**Service information SI\_2017\_111\_0073 T3**

<b>System type:</b> Precision / Intuition	<b>Serial numbers:</b> n.a	<b>Date issued:</b> 2017-12-01
<b>ServiceInfo number:</b> SI_2017_111_0073 T3	<b>Issued by:</b> Jonas Petersson	<b>Approved by:</b> Mikael Högberg
<b>Time for action:</b> ONLY IF PROBLEMS	<b>Report back to Arcoma:</b> No	<b>Ref nr: (ÄBO, Complaint)</b> 17-0007
<b>Subject:</b> <b>Anti-scatter grid position</b>

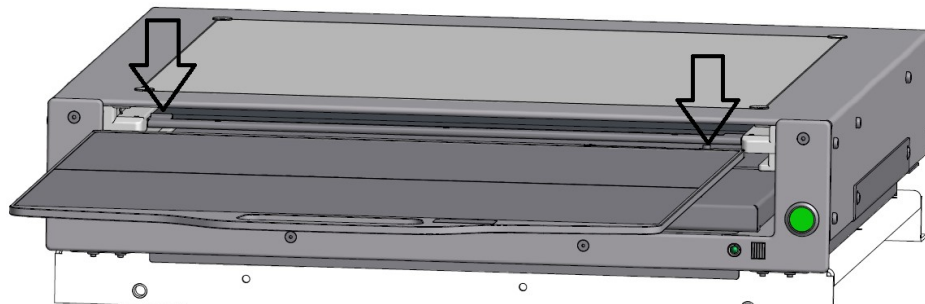
Arcoma received complaints related to the fact that anti-scatter grids can be inserted the wrong way in some models of detector holders for both table and wall stands.

Inserting the grid incorrectly may affect image quality and cause additional x-ray exposures to patients.

A mechanical device preventing incorrect insertion has also been implemented in production for the assembly of Precision system s/n 2105 and Intuition system s/n 2036. See image below.

Inform all users of the contents of this SI. The grid has a centre line that always must face the x-ray tube. Distribute updated page(s) for the manual where applicable.

- Install the upgrade kit and replace page(s) in the User manual in accordance to the supplied instruction.
